September 19, 1996

Enclosed please find a copy of the latest EEG report, *Stability Evaluation of the Panel 1 Rooms and the E140 Drift at WIPP*, EEG-63, by Dr. Hamid Maleki and Dr. Lokesh Chaturvedi. The report examines the stability of the panel 1 rooms and E140 drift.

DOE/AL/58309--63
EEG-63

STABILITY EVALUATION OF THE PANEL 1 ROOMS AND THE E140 DRIFT AT WIPP

Figure B-2. Anhydrite and clay interbeds above and below the WIPP repository.

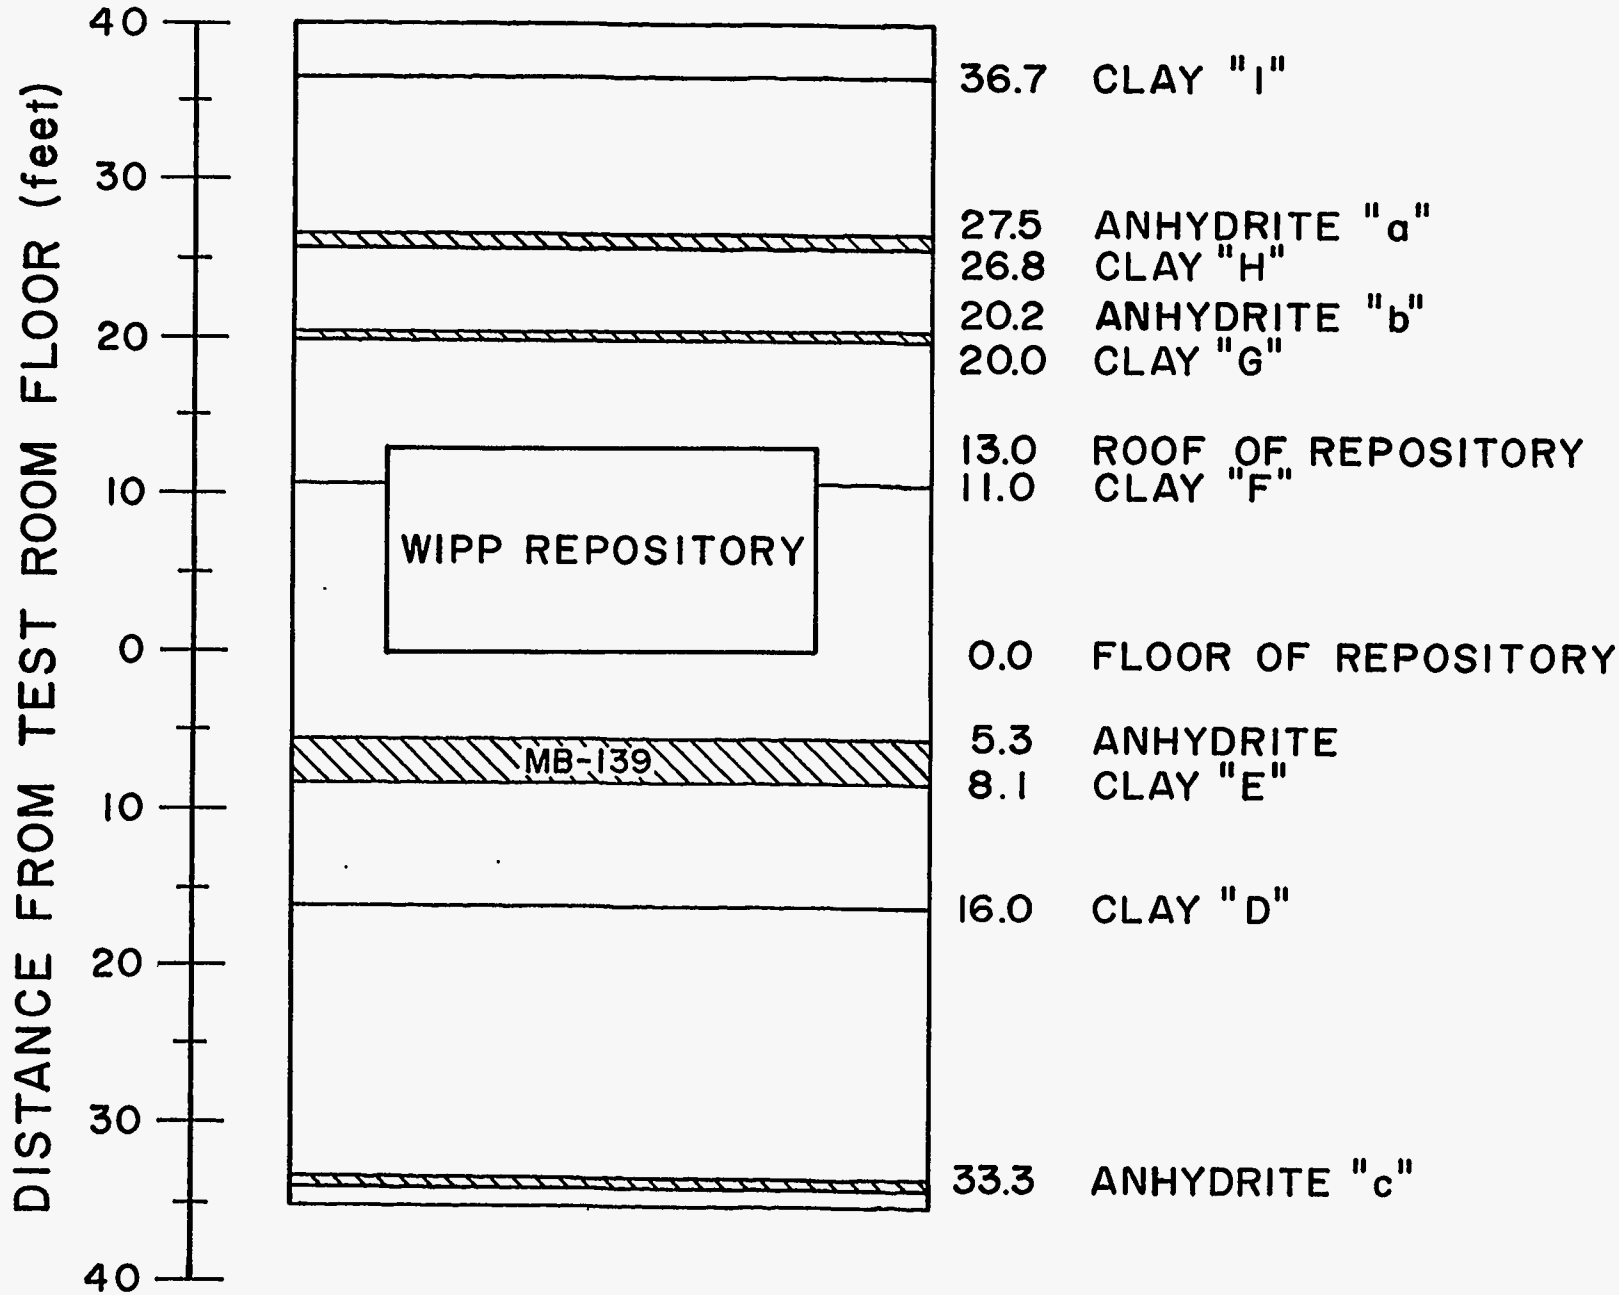
The potential for the anhydrite and clay interbeds to act as conduits for fluid flow has been recognized as a factor in the assessment of the WIPP repository to contain waste. Marker Bed 139 is located about 1.5 meters (5 ft) below the repository floor, and Anhydrite "a" and "b" layers and associated clay seams are located approximately 4 meters (13 ft) and 2 meters (7 ft) above the roof (Figure 2). The 1983 DOE evaluation of the WIPP Site and Preliminary Design Validation Program was used to qualify the WIPP site with respect to the "stratigraphy criterion" based on the following reasoning:

Does this statement remain valid for the panel 1 rooms, when: the interbeds above the roof have been allowed to be fractured; at least 286 connections have been made between the room and the fractured anhydrite "b" layer through roofbolts; and, the floor of the rooms is thoroughly fractured and connected with the underlying heavily fractured Marker Bed 139 through periodic milling of the floors?

Figure 7 - Room 1, Panel 1 support system. Steel chain is used to prevent the potential for free fall of threaded rebars in the future.

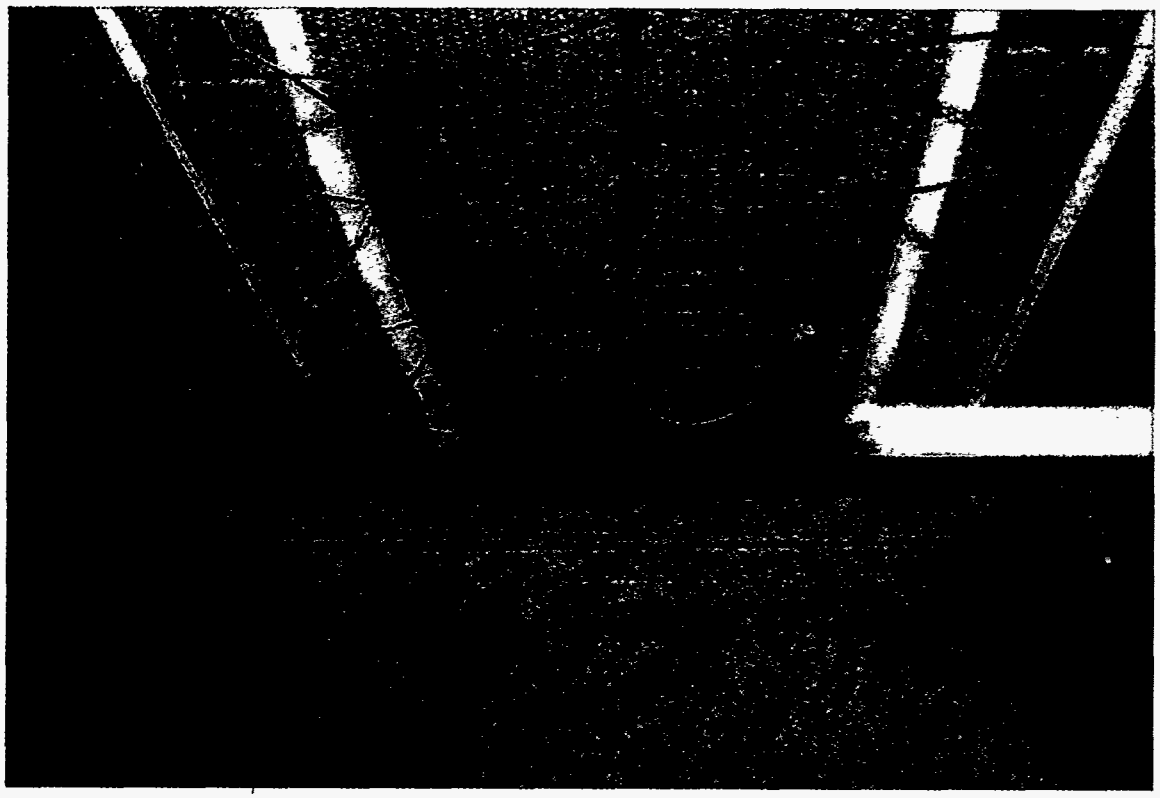
What is the safe life of the rooms with a supplementary roof support system? The design report for the system stated the goal was to "extend the life of Room 1 to allow completion of the experiments, for an additional period of up to seven years (from July 1991) (U.S. DOE 1991c). The project has claimed that the room 1 support system was installed to minimize the need for ground control activities during radioactive waste experiments; otherwise, the rooms can be kept stable by ground control activities. Since the process of waste emplacement will not allow frequent ground control activities, it is obvious that supplementary roof support systems will have to be installed in rooms 2 through 7 if these rooms are to be used.

The DOE has claimed, "The minimum life of the installed support system is estimated at 15 years based on the highest roof expansion rate experienced to date" (U.S. DOE 1993a). This statement was based on the remaining 21.6 cm (8.5 inch) length of the

roofbolt "tails" available for adjustment and the assumption that the 1.4 cm (0.56 inch) roof expansion during the first year would remain constant for 15 years, and without considering the effect of lateral offset. If the roof expansion rate changes, the estimate would change. Similarly, a critical factor in the predicted stability of the roof support system is the assumption that separation at the anhydrite "a" layer, 4 meters (13 ft) above the roof, would not be such that the whole 4 meter (13 ft) beam becomes unstable. The system is anchored below the anhydrite "a" horizon.

Figure 8 - Estimated roof-floor convergence for two rooms of Panel 1.

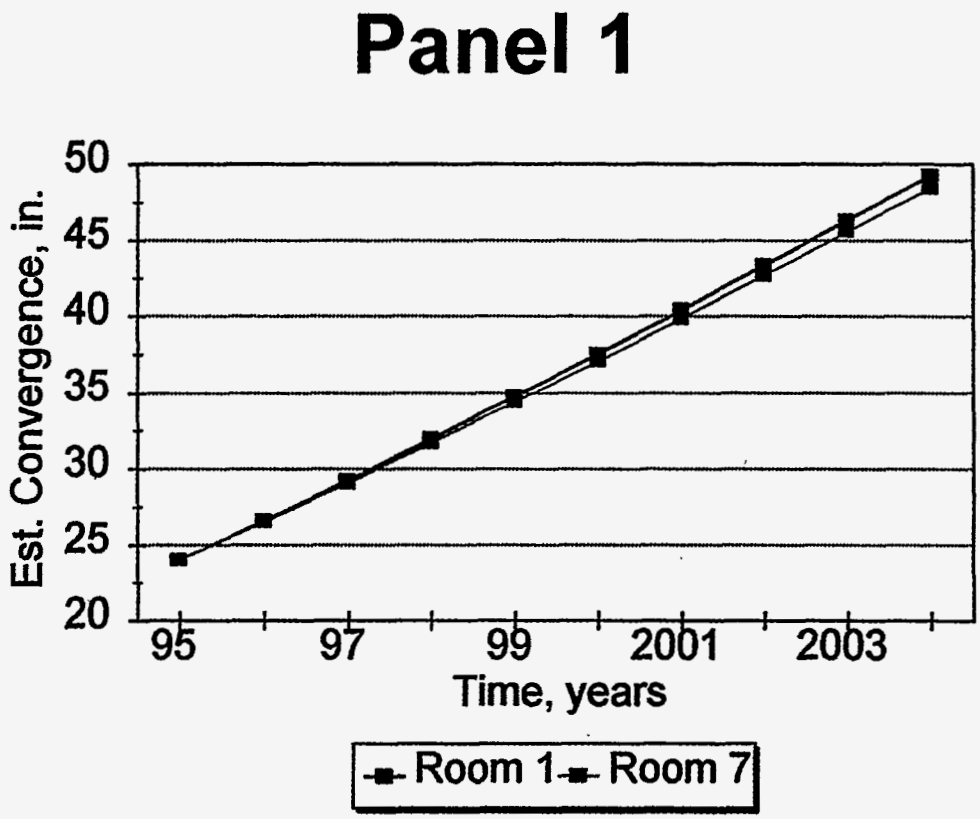
Having developed a relationship among convergence rate, mining, and time variables, total roof-floor convergence can be calculated for both E140 and Panel 1. For this, we have used average measured convergences using 1995 as the base and have added expected convergence for the anticipated life of the entries (Figure 8). The calculated difference in movements for Room 1 and 7 is due solely to age differences, because other analyzed variables, such as bolting parameters, were found to be insignificant. In reality, the special support system in Room 1 provides some safety advantages in the short term, but these advantages can be expected to become ineffective before the turn of the century for the following reasons:

unchanged in the future, expected roof movements will also double during this period. Figure 8 presents estimated total convergence for Rooms 1 and 7.

Figure 9 - Estimated convergence for E140 drift.

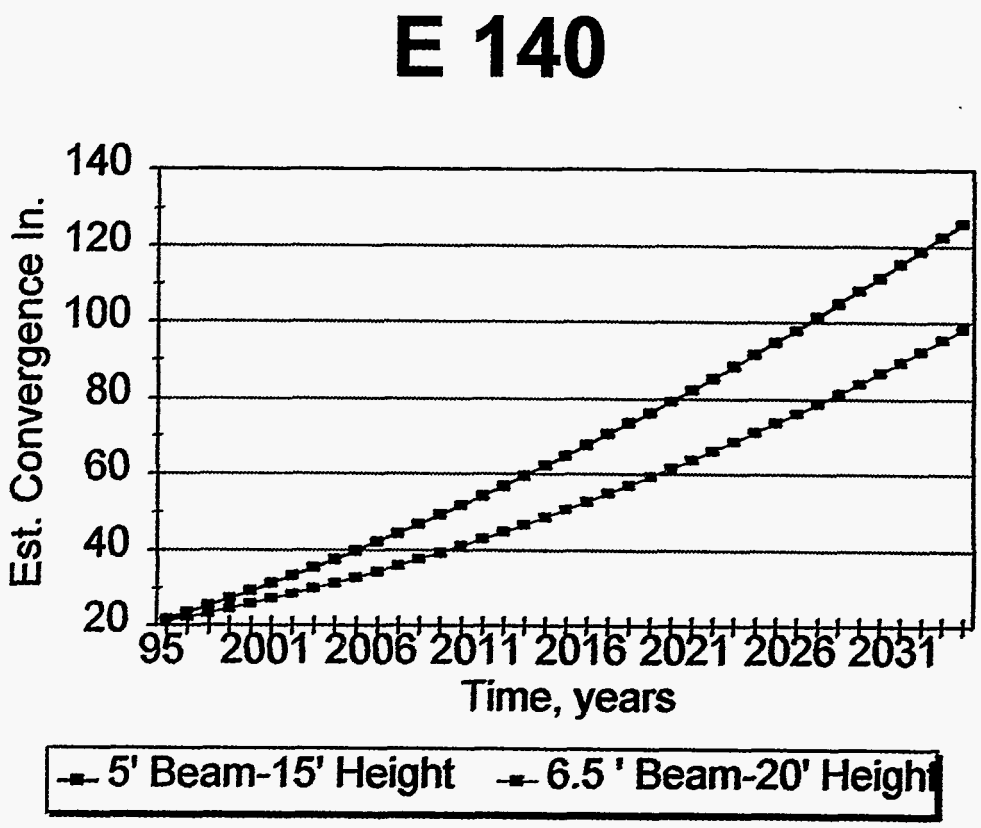
The regression equation was used to estimate total roof-floor convergence in E140 for the remaining life of these entries. Figure 9 presents results for two typical conditions where the immediate 5-ft beam is in place and at locations where the immediate beam is removed (a 20-ft-high and 6.5-ft-thick beam directly above clay G).
